Regional Review Finding

Development of Regional Impact

RE: Development of Regional Impact (DRI) Review

Name of Proposal: Creekside Village Mixed-Use Development DRI 4478

FEMA FLOOD MAP

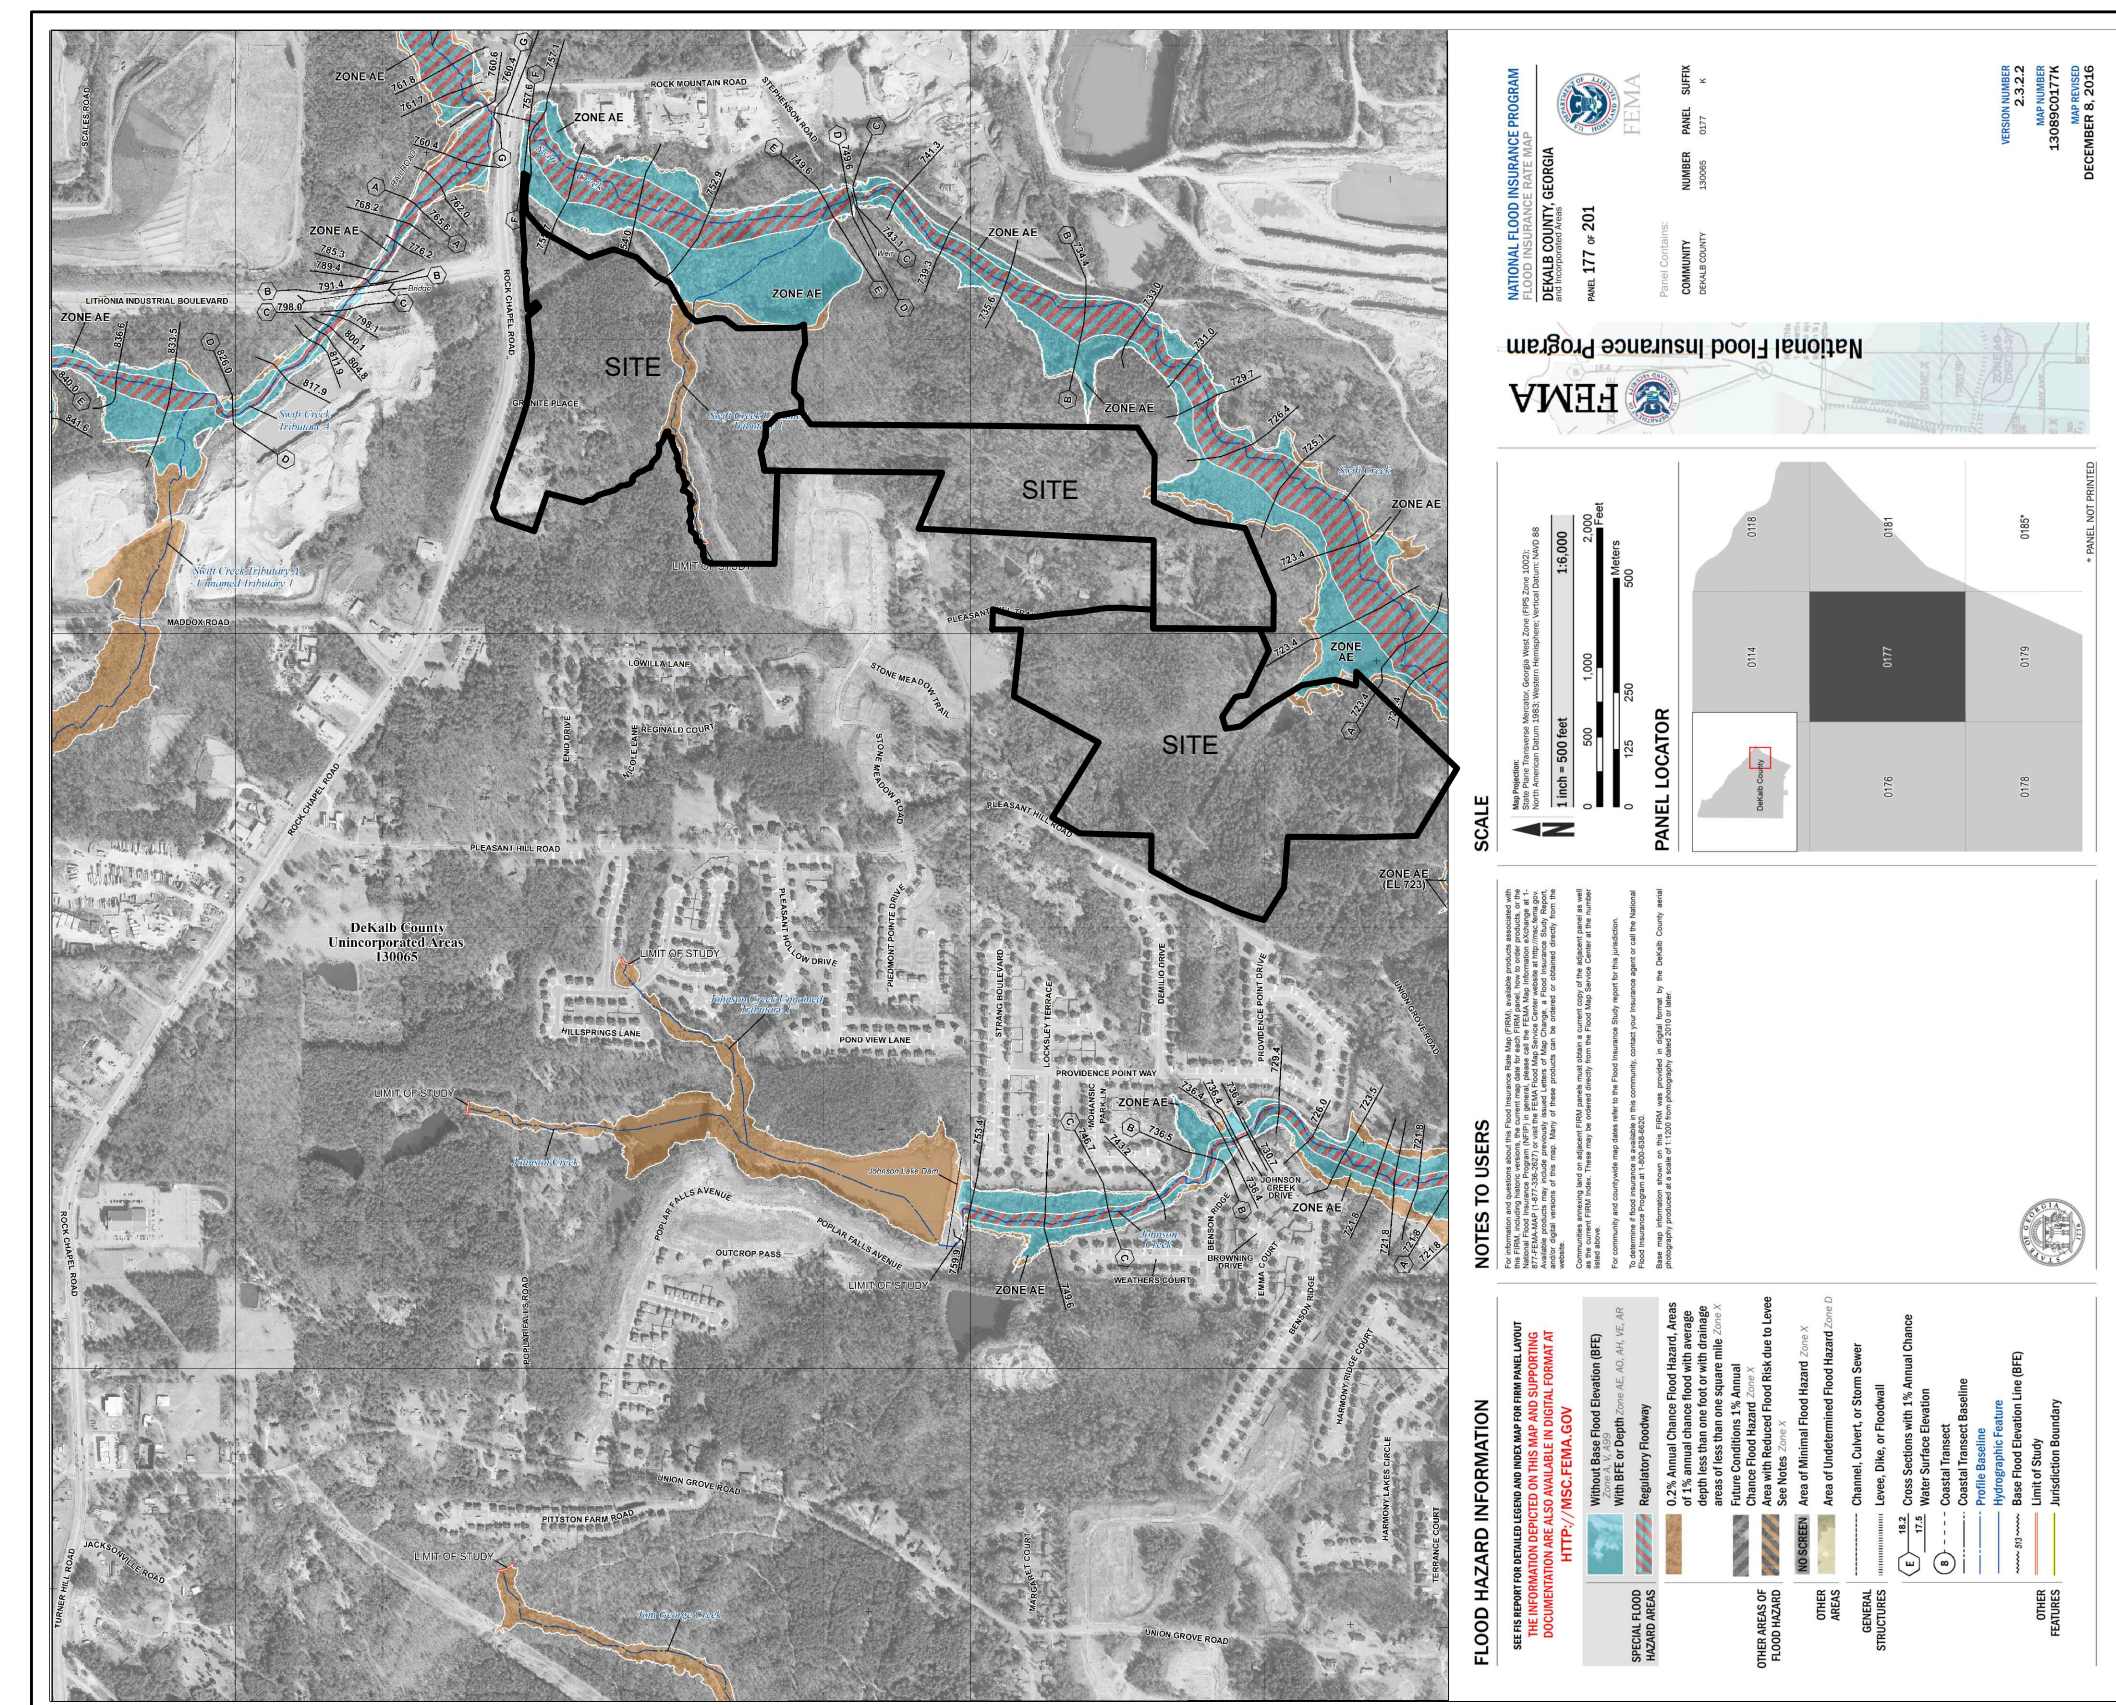
The FEMA coverage for the project area shows both the 100 -year floodplain (Zone AE), the 500-year floodplain (Zone X) and the floodway along Swift Creek, as well as the 500-year floodplain along the tributary closest to Rock Chapel Road. The Swift Creek 100-year floodplain is shown on the project site plans but has only small intrusions at the edges of the property. The Swift Creek 500-year floodplain is not shown on the plans but based on the FEMA coverage, appears to be entirely within the conservation portions of the proposed project. The floodplain on the tributary closest to Rock Chapel Road is identified as 100-year floodplain on the site plan but is shown as 500-year floodplain on the FEMA coverage. The floodplain along the tributary should be corrected and any Swift Creek 500-year floodplain on the property should be shown and identified.

The floodplain on the tributary closest to Rock Chapel Road is identified as 100-year floodplain on the site plan but is shown as 500-year floodplain on the FEMA coverage. The floodplain along the tributary should be corrected and any Swift Creek 500-year floodplain on the property should be shown and identified.

SHEET NUMBER
3.0

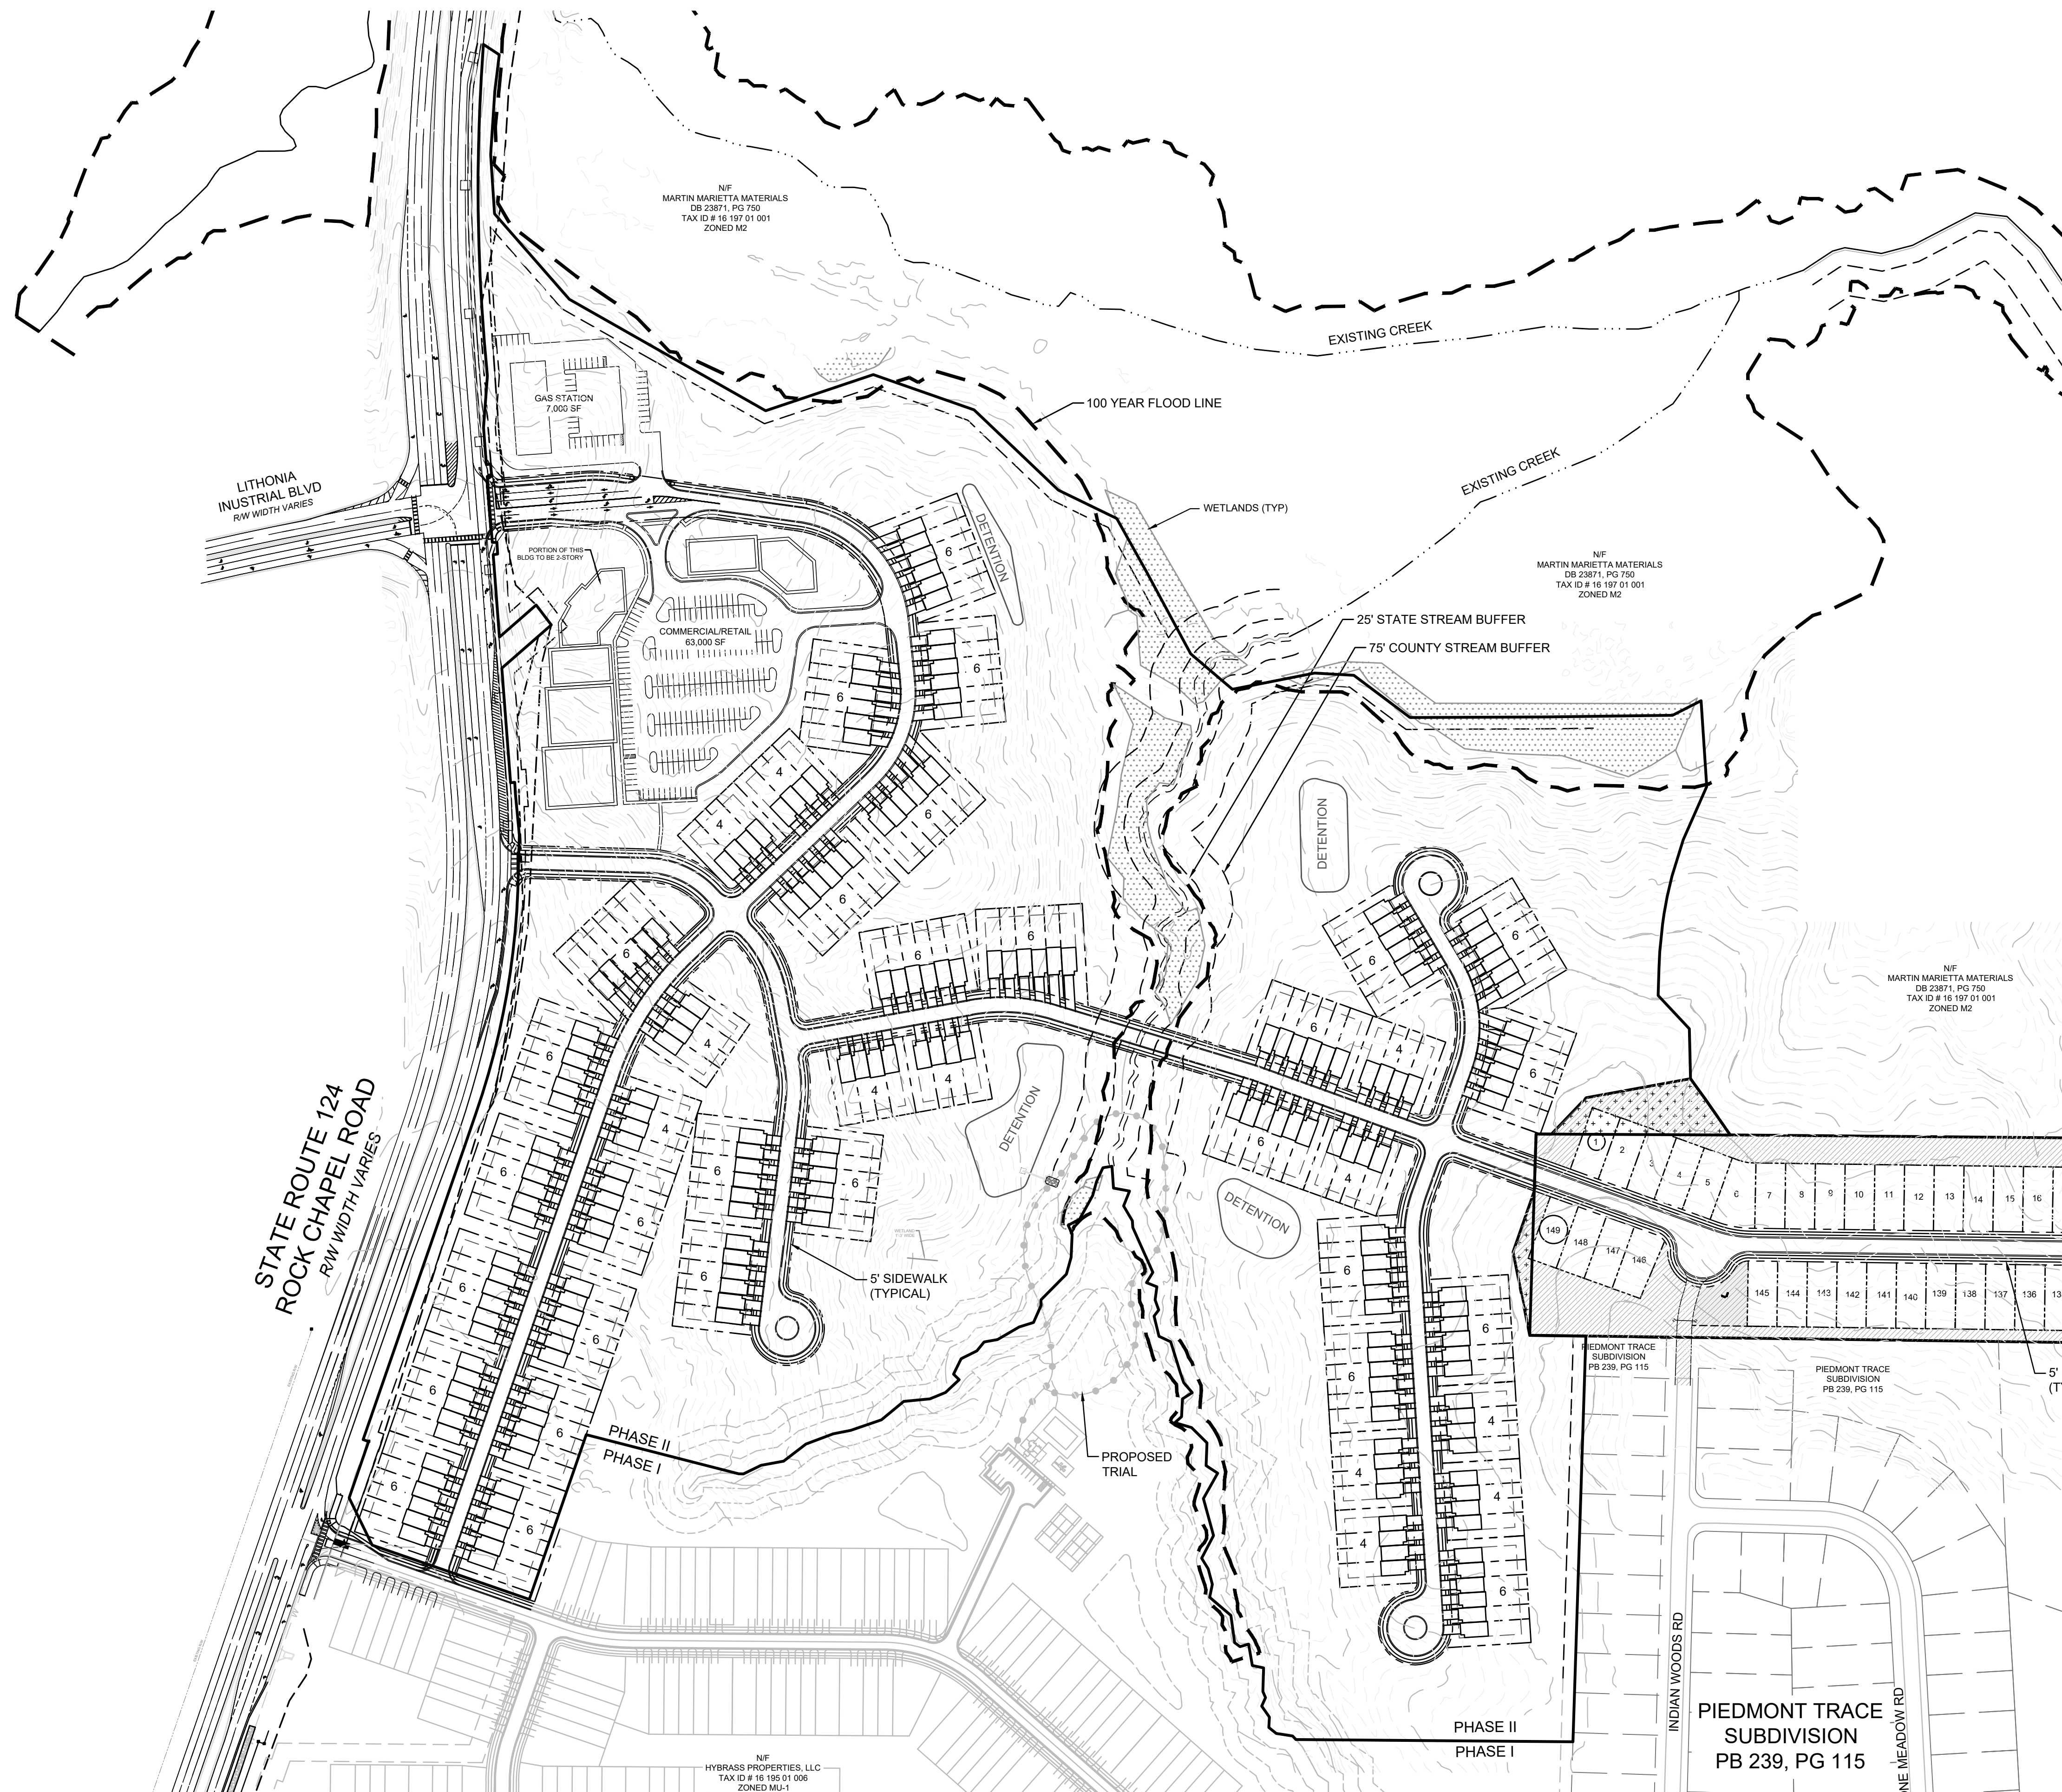
Swift Creek, a direct tributary to the Yellow River, runs to the north and east of the project property and is shown as a blue-line stream on the USGS coverage for the project area but based on the submitted site plan, the project property does not extend to the creek. The Yellow River itself is near but not abutting the southeastern corner of the project property. The submitted site plan shows four tributaries to Swift Creek on the property, none of which are shown on the USGS coverage for the project area. The County 75-foot stream buffer and the State Sediment and Erosion Control buffers are shown and identified along Swift Creek and the three easternmost streams on the property. The stream closest to Rock Chapel Road shows buffers, but they are shown as a 50-foot undisturbed buffer and additional 25-foot impervious setback and the 25-foot State Buffer is not identified. The County buffer is defined as 75-foot in County ordinance, Sec. 14-44.1. - Land Development Requirements and the State 25-foot buffer applies on all streams. The buffers on this stream need to be corrected. No intrusions other than transportation crossings, which are allowed under the County ordinance, are shown on the submitted plans. SITE PLAN IN FINAL REPORT IS CORRECTED

Swift Creek, a direct tributary to the Yellow River, runs to the north and east of the project property and is shown as a blue-line stream on the USGS coverage for the project area but based on the submitted site plan, the project property does not extend to the creek. The Yellow River itself is near but not abutting the southeastern corner of the project property. The submitted site plan shows four tributaries to Swift Creek on the property, none of which are shown on the USGS coverage for the project area. The County 75-foot stream buffer and the State Sediment and Erosion Control buffers are shown and identified along Swift Creek and the three easternmost streams on the property. The stream closest to Rock Chapel Road shows buffers, but they are shown as a 50-foot undisturbed buffer and additional 25-foot impervious setback and the 25-foot State Buffer is not identified. The County buffer is defined as 75-foot in County ordinance, Sec. 14-44.1. - Land Development Requirements and the State 25-foot buffer applies on all streams. The buffers on this stream need to be corrected. No intrusions other than transportation crossings, which are allowed under the County ordinance, are shown on the submitted plans.
